Access Compliance Report

Public Rights-of-Way

(Curb Ramps)

Intersection ID: N/A	Main Street: COMMUNITY_HOUSE_RD	Cross Street: N/A	Location: NE
ADA ID: A5D4496D491B	Ramp Type: Perp	Initial Pass/Fail: Fail	Overall Compliance: No
Severity Score: 1.25			
Codes/Mitigation Info/Possible Solution		Field Measurements/Component Compliance

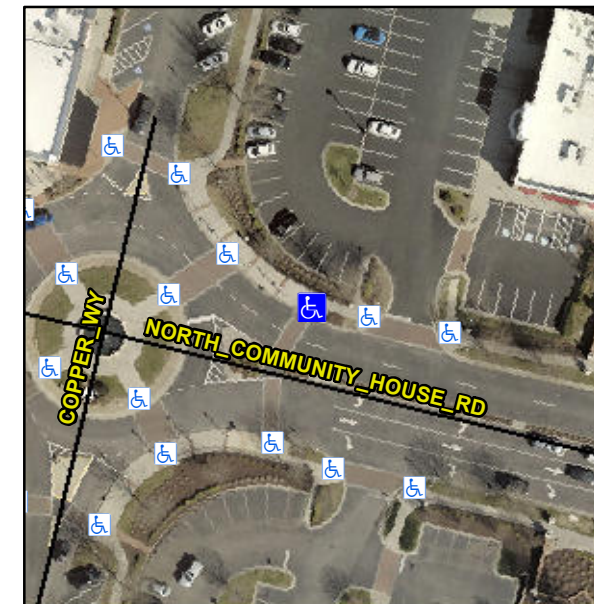
R304.5.3

Compliance	Description	Data	Compliance	Description	Data
N/A	Ramp Length (in)	130.0	Yes	Ramp Slope (%)	6.6
Yes	Ramp Width (in)	118.5	No	Ramp XSlope (%)	4.4
N/A	Flare Type LT	N/A	N/A	Flare Type RT	N/A
N/A	Flare Slope LT (%)	N/A	N/A	Flare Slope RT (%)	N/A
N/A	Flare Traversable LT?	N/A	N/A	Flare Traversable RT?	N/A
N/A	Landing Length (in)	N/A	N/A	DWS Provided?	N/A
N/A	Landing Width (in)	N/A	N/A	DWS Contrast?	N/A
N/A	Landing Slope (%)	N/A	N/A	DWS Length (in)	N/A
N/A	Landing X Slope (%)	N/A	N/A	DWS Full Width?	N/A
N/A	Landing Curb? (Y/N)	N/A	N/A	DWS Offset (in)	N/A
N/A	Shared Landing?	N/A			
N/A	Gutter Ponding?	N/A	N/A	Gutter Slope (%)	N/A
N/A	Gutter Lip Ht (in)	N/A	N/A	Gutter X Slope (%)	N/A
N/A	Painted X Walk1?	Yes	N/A	Painted X Walk2?	N/A
	X Walk 1 Direction	To SW		X Walk 2 Direction	N/A
N/A	X Walk 1 Width (in)	99.0	N/A	X Walk 2 Width (in)	N/A
	X Walk 1 Slope (%)	1.1		X Walk 2 Slope (%)	N/A
	X Walk 1 X Slope (%)	1.5		X Walk 2 X Slope (%)	N/A

Remove & Replace Entire Ramp.
